# Compliance inspection following a fatality at level crossing XM096, 2 September 2010

## Executive Summary

Figure 4: Site Layout with available views (measured 30th Sept 2010)

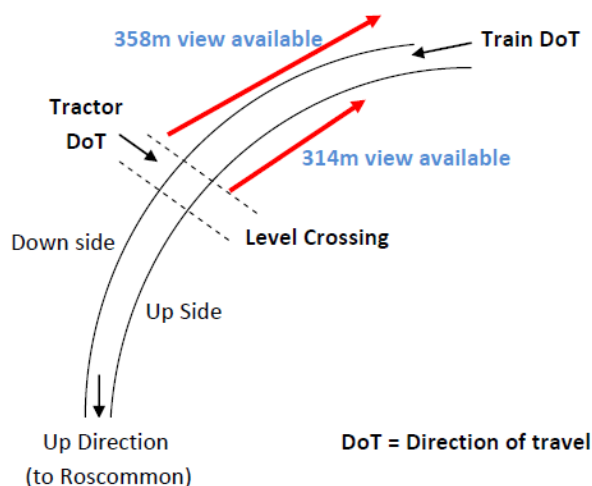
It is noted that the tractor travelled across the level crossing from the down side to up side and that the available sighting for such a movement met the requirements of the MW50 standard. Equally the RSC is mindful of the fact that the train involved in the collision was a freight train which had a permissible speed of 50 mph and this speed limit was observed.

The crossing was surveyed after the collision, on 30 September 2010, and the viewing distance in the down direction from the up side for the line was recorded as 314m. This is less than that required by Standard MW50 which, as previously stated, requires 350m for a train speed of 70 mph on single line track which is the speed limit for passenger services on this section of track.

- A whistle board was erected on the approach to crossing XM096 from the up direction on 2<sup>nd</sup> October 2010 in accordance with the Technical Information Sheet MW50, Section 4.
- Phase II of the new 'O' & 'OP' signs were installed to crossing XM096 on 15<sup>th</sup> September 2010.
- A review of the viewing distances at all unattended level crossings on the Mayo line was undertaken. Where deficiencies were identified, whistle boards were erected in accordance with Technical Information Sheet MW50, Section 4.4.
- A programme of view improvements has been initiated at user worked crossings along the route. This has led to a further reduction in the risk rankings at the crossings.
- A Works Order has been generated to cut the vegetation on the land of a third party that will improve the view looking in the Down direction from the Up side. The landowner gave consent for the work.
